**Dear STOL builder:**

TOP CHANNEL ZEE REINFORCEMENT

**F5-3Z**

PART NUMBER: 7F5-3Z

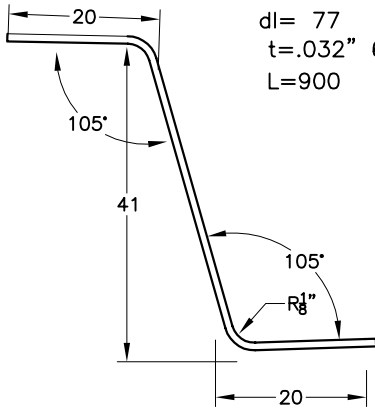
For those of you who may be operating the aircraft in excess of the published VNE and/or at weights higher than the published gross weight figures (you know who you are!), I recommend that the Top Channel be reinforced (see following drawing F5-3Z). Two such aircraft have been reported to have shown signs of buckling along the middle portion of the Top Channel.

ADDITIONAL REINFORCEMENT Z ANGLE  
WHEN 7F5-3 OR 7F5-3SP IS t=.040"  
(NOT REQUIRED IF 7F5-3SP IS  
t=.063")

dI= 77  
t=.032" 6061-T6  
L=900

PART NUMBER: 8F5-3Z

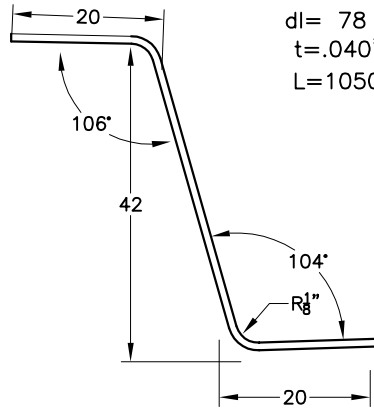
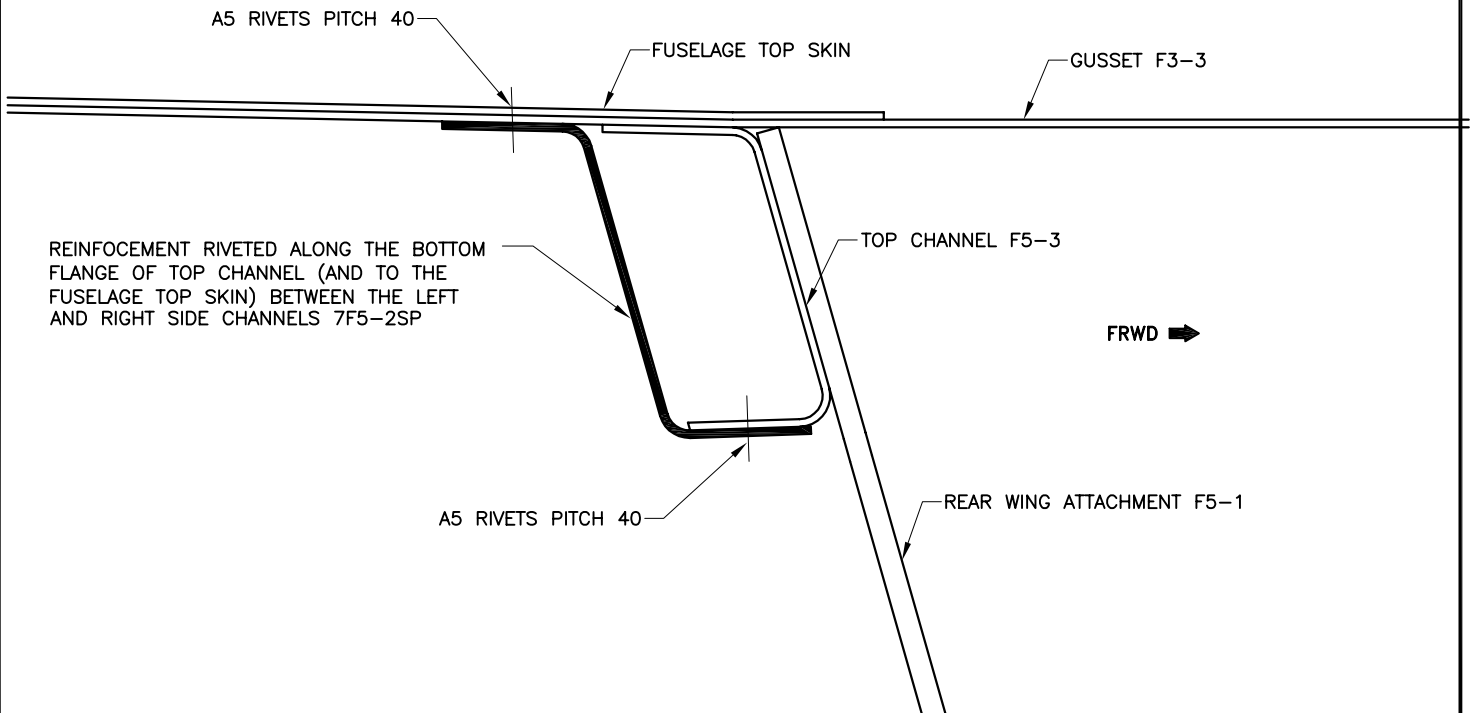
ADDITIONAL REINFORCEMENT Z ANGLE  
WHEN 8F5-3 IS t=.040"  
(NOT REQUIRED IF 8F5-3 IS t=.063")

dI= 78  
t=.040" 6061-T6  
L=1050
